PARKS FACILITIES AGREEMENT

(BLOOM MONTGOMERY VILLAGE)

RE: Plan #120170160 Bloom MV

RE: Preliminary Plan & Design Exception Letter
Preliminary Plan No. 120170150
Bloom Montgomery Village

BLOOM AV
AREAS I-IV
RESIDENTIAL DEVELOPMENT
COMPOSITE PLAN
DATE: 2023-10-27
SCALE: AS SHOWN

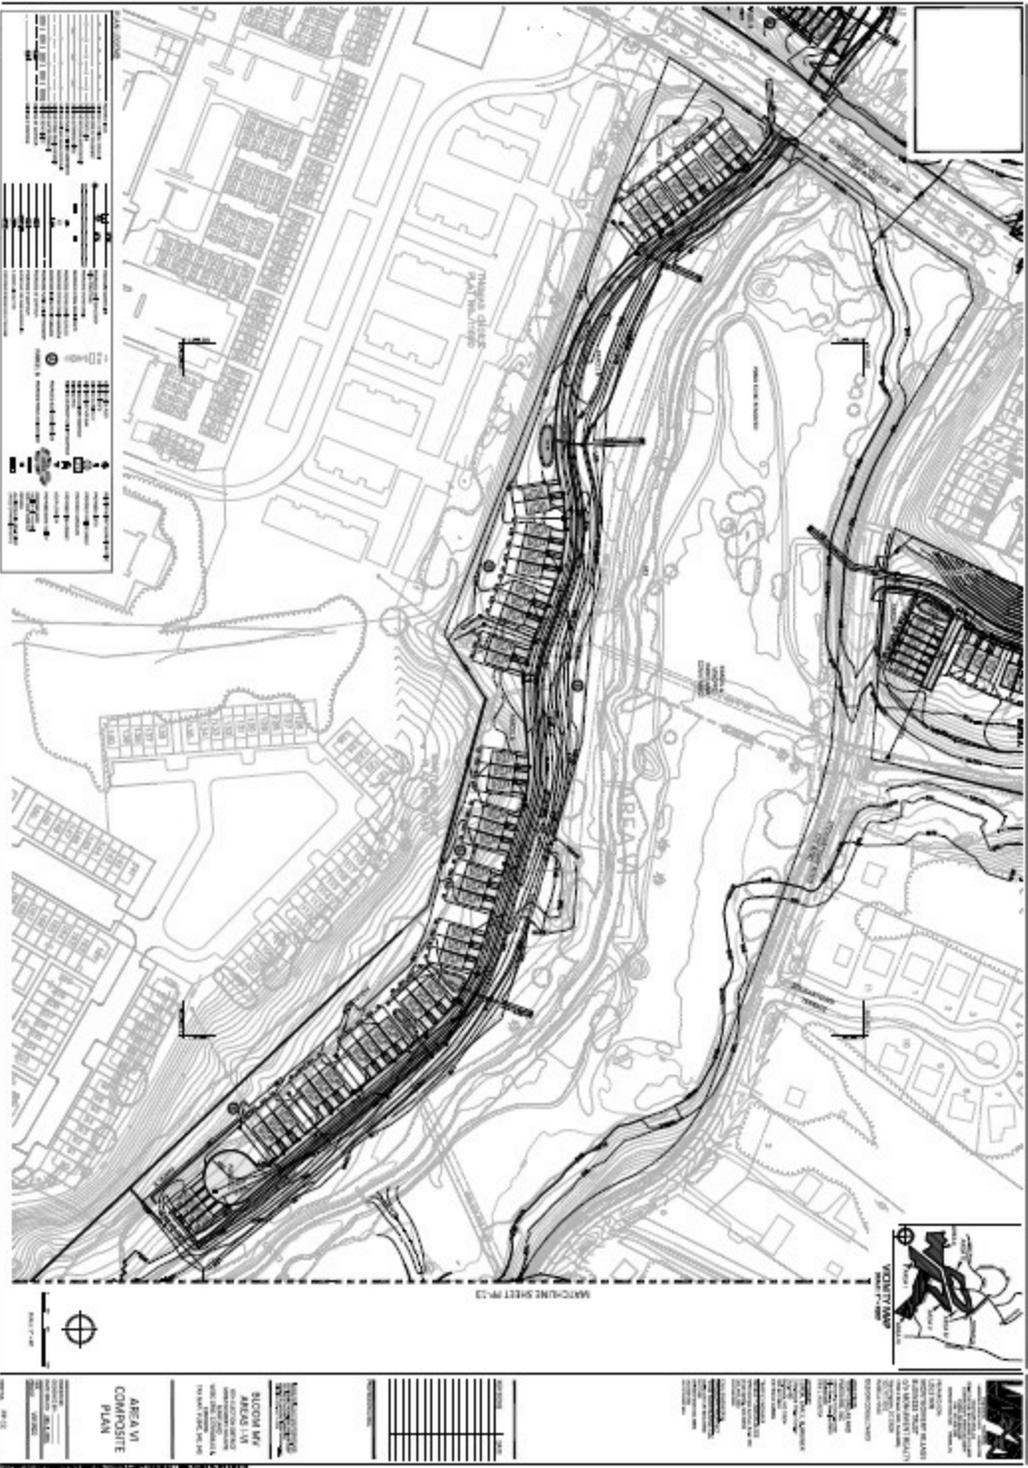
- Road connection cuts close to houses and is unnecessary. Change to 2 roads.
- Rotate lots #1 - #6 to face the stream valley like the others.
- Rotate Lots #12 to 15 to align with 7-11 and 20-25. Eliminate lots 16-19.
- Eliminate the connecting road along Parcel C.
- Rotate whole area with lots 1-27 clockwise by about 20 degrees and move the units away from neighborhood lots 15-22.
- Consider linking road to greenside terrace vs. traversing over towards Arrowhead .

- The whole area floods badly. The road will be a maintenance nightmare and is impractical. Delete ALL 49 Townhouses.
- If retained as a private road, the homes will eventually seek relief via county ownership.
- If conveyed to the county, the maintenance cost will be large and perpetual.
- The **ONLY** acceptable way to allow these is to require that the builder provide a bond of sufficient size to maintain the road **IN PERPETUITY**. Approximate rebuild cost is \$300k every 3 years, so a \$3M bond.

- Lots 15-28 lack ANY backyard area, are “squished” against the commercial building on the south side. Move these units 20’ to the North by deleting lot 1 and 14 and moving the road north.
- Delete 2 Townhouses (#1, #14).
- This area is ISOLATED and lacks any usable recreation space. Parcel F does not count as it is circled in a road. Builder should remove at least 2 acres from the “MNCPPC Conveyance” in the area where the pond is removed, and level that area as a flat grassy playing field for recreation, and add a swing set and slide.

- Consistent with MVF Approved concept plans for 350 units. Lower cost infrastructure. More greenspace.

- Revisions bring plan back in line with concept plans.
- Consistent with MVF Approved concept plans for 350 units.
- More green space.
- Less infrastructure & roads.
- Adds walking path corridors.

BLOOM MV
 AREAS I-VI
 17th ELECTION DISTRICT
 HIGHWAY 28, MARYLAND COUNTY,
 WISCONSIN
 TOWN MAP PUBLIC, JUL 2003
 PP # 120370150

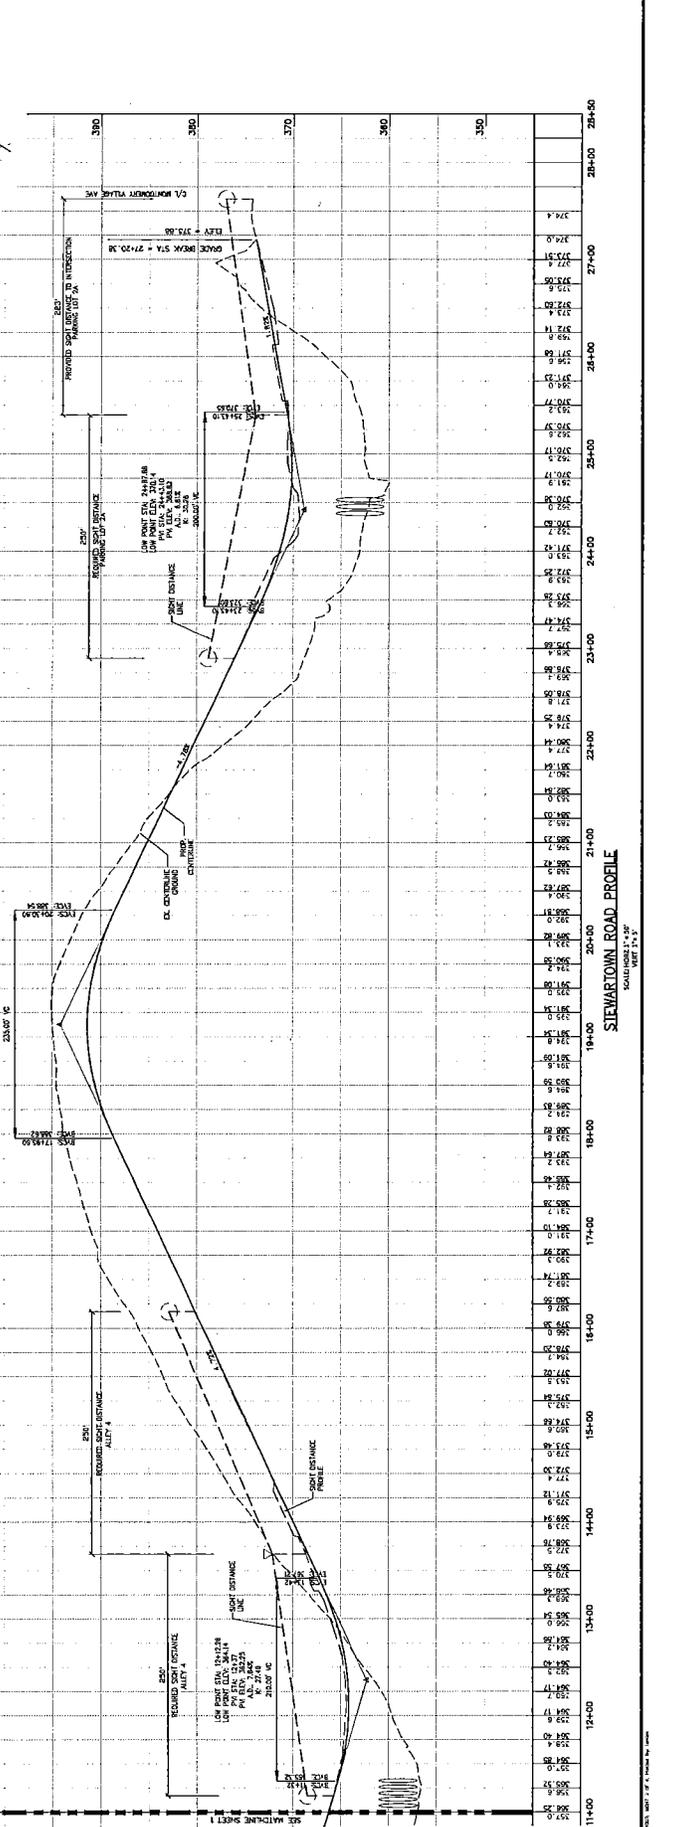
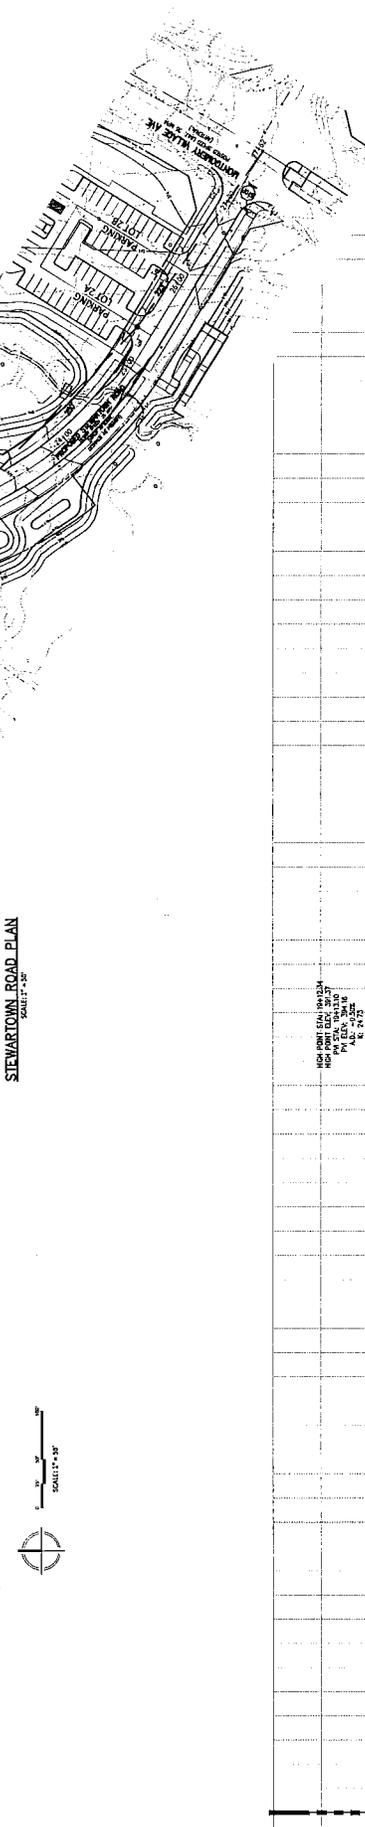
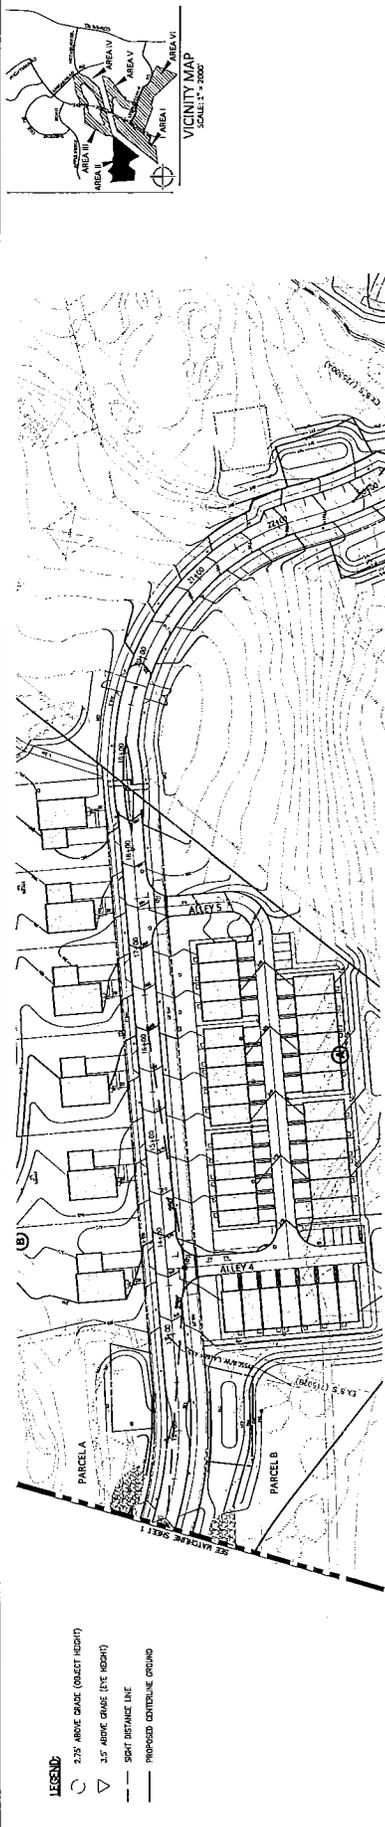
6. Sheet PP-01: The proposed Stewartown Road cross sections (with and without parking) should be reversed to match the proposed roadway centerline stationing on the Certified Preliminary Plan.

- c) We do not support installation of the proposed curb bump outs at STA 25+00 on proposed Stewartown Road because it provides a narrower pavement section than that recommended in the master plan; they should be removed from the drawing prior to approval of the Certified Preliminary Plan.

- a) We recommend that the proposed mid-block pedestrian crossing be relocated to west side of the intersection the proposed driveway entrance (Parcel 'R') with proposed Stewartown Road. The proposed location of the pedestrian crossing will be a safer location than the one shown in the plan as it is farther away from the proposed horizontal curve and is located at the intersection.
- b) The proposed single family driveway entrance shall be aligned with the proposed driveway entrance (Parcel 'R') on the opposite side of proposed Stewartown Road on the Certified Preliminary Plan.
- c) The proposed single family driveway entrance shall be aligned with the proposed driveway entrance (Parcel 'P') on the opposite side of proposed Stewartown Road on the Certified Preliminary Plan.

Fire Department Access Review

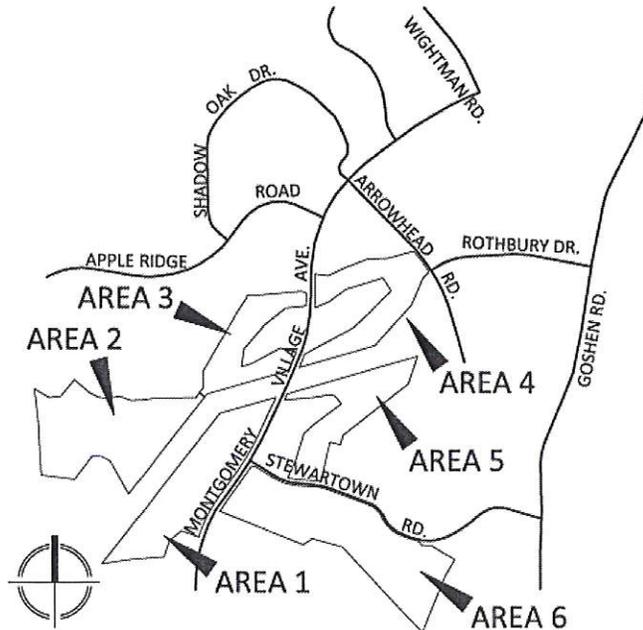
Review based only upon information contained on this plan. Does not cover unsatisfactory layout resulting from omissions, errors or failure to clearly indicate conditions on this plan. Correction of such unsatisfactory layout to afford required access will be required if found upon inspection after installation
